Office Action Summary	Application No. 10/569,229	Applicant(s) ATAKE, HIROYUKI	
	Examiner AMJAD ABRAHAM	Art Unit 1744

DETAILED ACTION

3. Claims 1-6 are rejected under 35 U.S.C. 103(a) as being unpatentable over Atake (USP No. 6,325,607) in view of Yamazaki (JP 05-278065 – already made of record).

FIG. 5

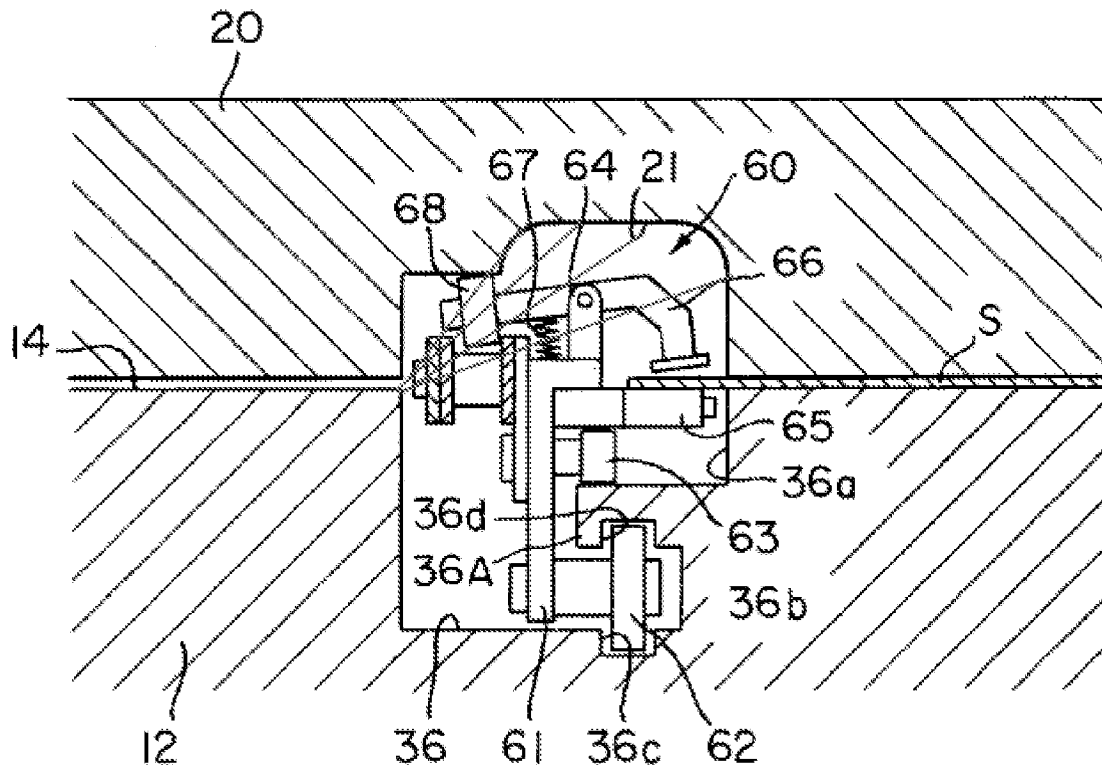
viii. Wherein the clamper is formed in such a way that when the pushing frame (rectangular portion of part 20) contacts the parting surface (14) of the female mold—there is a space between the connecting member and the parting surface. **(See figures 4-5, column 7 lines 43-52, and column 12 lines 19-31).**

(11) See figure 5 depicted below--- The lines emanating from parts 21, 64, 66, and 67 to a common point on the parting surface of the female mold show the space between the connecting member and the parting surface.

r. However, the entire horizontal plate (the area between and including rods 24 of figure 2) of the clasper (20) can be considered a part of the connecting member. Thus it is this connecting member (20) which is shown in figure 5.

Therefore the connecting member and parting surface of Atake form a space which allows the clamping device to pass through. Examiner would like to further
